City of Fairfax, Virginia  
City Council Work Session

SUBJECT: Discussion of a request of Pulte Homes for a City Council work session to discuss the proposed redevelopment of the Breezeway Motel, Fairfax Gardens Apartments and several adjacent residential lots into a residential planned development.

Re: Request for Work Sessions  
 Proposed Redevelopment of the Breezeway Motel Assemblage

# Proposed Redevelopment of Breezeway Motel

ROUTE 50 FAIRFAX CITY BY PULTE GROUP - ILLUSTRATIVE LAYOUT  
FAIRFAX CITY, VIRGINIA

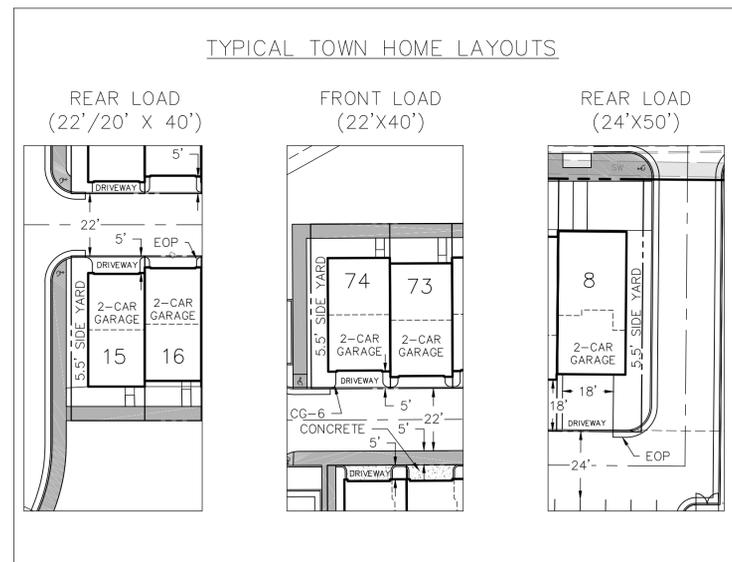
The applicant proposes three entrance/exit access points into the northern section of the site from Fairfax Boulevard, Walnut Street and Cedar Avenue and only one entrance/exit for the southern section onto Cedar Avenue. Staff questions the need for three access points for the northern section.

Parking: The applicant’s parking tabulations give the impression of an overabundance of parking compared to what is required; however, on street parking on a City road may not be included in parking calculations for the development.

The applicant’s parking tabulations use 1 space per 300 square feet for the commercial uses. Without knowing what uses are proposed in the live-work units at this time, the best course of action would be to use the 1 space per 200 square feet requirement which includes uses such as medical offices, general retail, general and personal services which are possible tenants of those spaces. Using the 1/200 calculation, the required parking for the commercial component is 29 spaces. The applicant’s parking table refers to the garage and driveway spaces for those units as the designated parking for the commercial uses. It is far more likely that the garage spaces would be utilized for the upper living quarters and the nearby surface parking be used by customers for the businesses.

Bicycle parking and storage facilities are required for all non-residential uses. This proposal would require 2 bicycle parking spaces. The plan does not show any proposed bicycle parking for the commercial uses at this time although there appears to be adequate space on site to incorporate it.

The applicant is proposing a sidewalk network throughout the site that connects the surface parking to the units and existing sidewalks along the adjacent roadways. However, staff is concerned about the pedestrian circulation for the customers for the live-work units. There is no sidewalk along the access road from Fairfax Boulevard. With no break between the 8 units, it is unlikely that a visitor to the end units close to the access drive will choose the only safe option provided to walk to Walnut Street and around the corner to the fronts of those units on Fairfax Boulevard. A break between units 4 and 5 with a pedestrian walkway leading from Fairfax Boulevard to the rear parking or a walkway along the access drive would provide a safer and more convenient alternative than walking in the access drive.
